SITE PLAN for
SIGNATURE HOMES Inc.
BAIN FARM SUPERVISION, CONCORD

SUBLOT # 5

SITE PLAN for
 SIGNATURE HOMES Inc.
 BAIN FARM SUBDIVISION, CONCORD

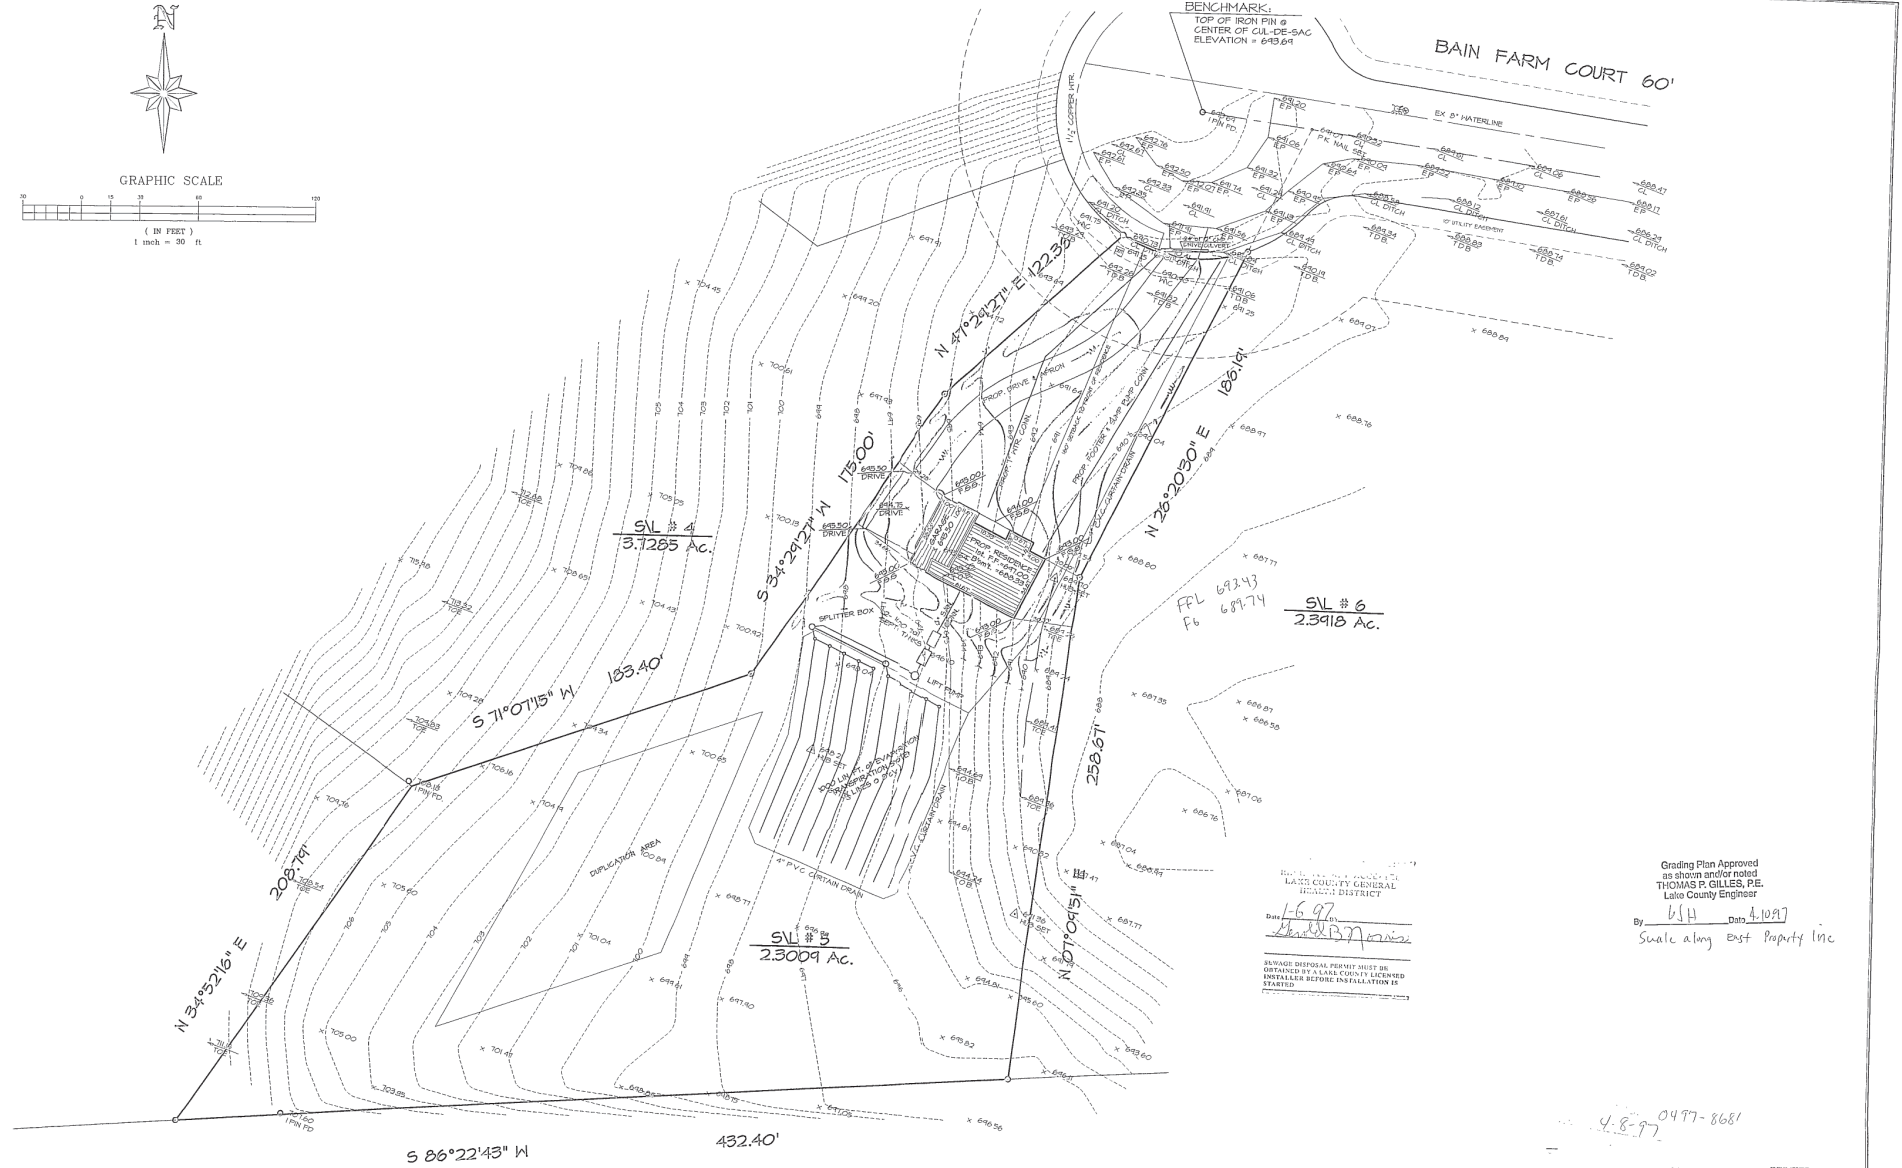
Grading Plan Approved
as shown and/or noted
THOMAS P. GILLES, P.E.
Lake County Engineer
By: LSH Date: 4.10.97
Swale along ext. Property line
